CDP-C235/C335

SONY SERVICE MANUAL

SUPPLEMENT-2

Subject : Positioning the Encoder When Attaching the Gear (MAIN)

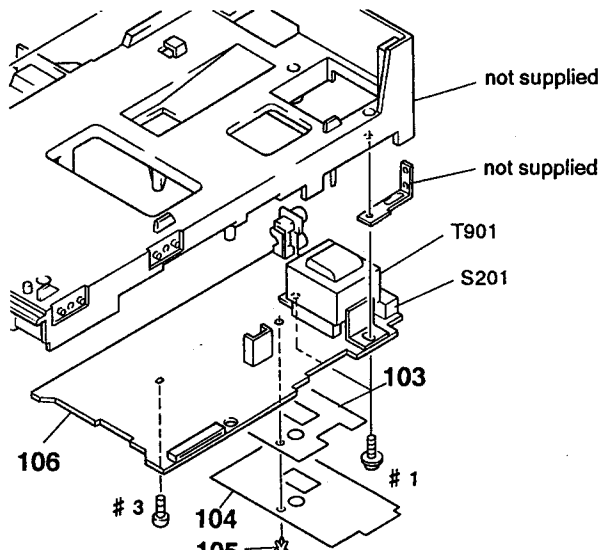
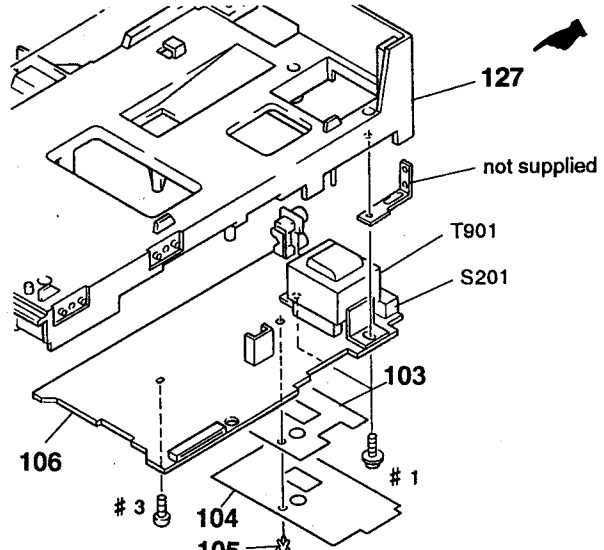
The position of the rotary encoder must be adjusted when attaching the gear (MAIN). If its position is not adjusted properly, problem may occur afterwards during operation.
